SERVICE BULLETIN

No. 354B

Piper Aircraft Corporation

Subject: Fuel Selector Valve Lubrication

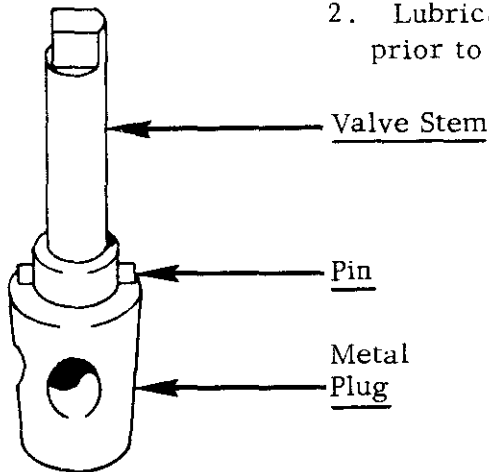
Brass Washer - counterbored; to reinstall properly, counterbored surface must face the position washer.

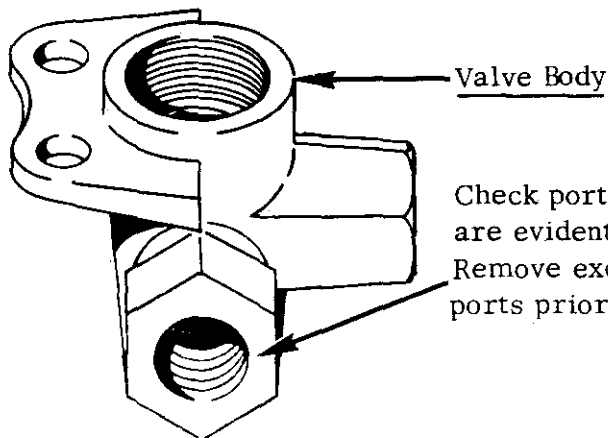
Position Washer
1. Check inside perimeter for indication of extreme wear; if wear is readily apparent, replace position washer.
2. Lubricate with MIL-G-6032 (Type I) prior to reinstallation.
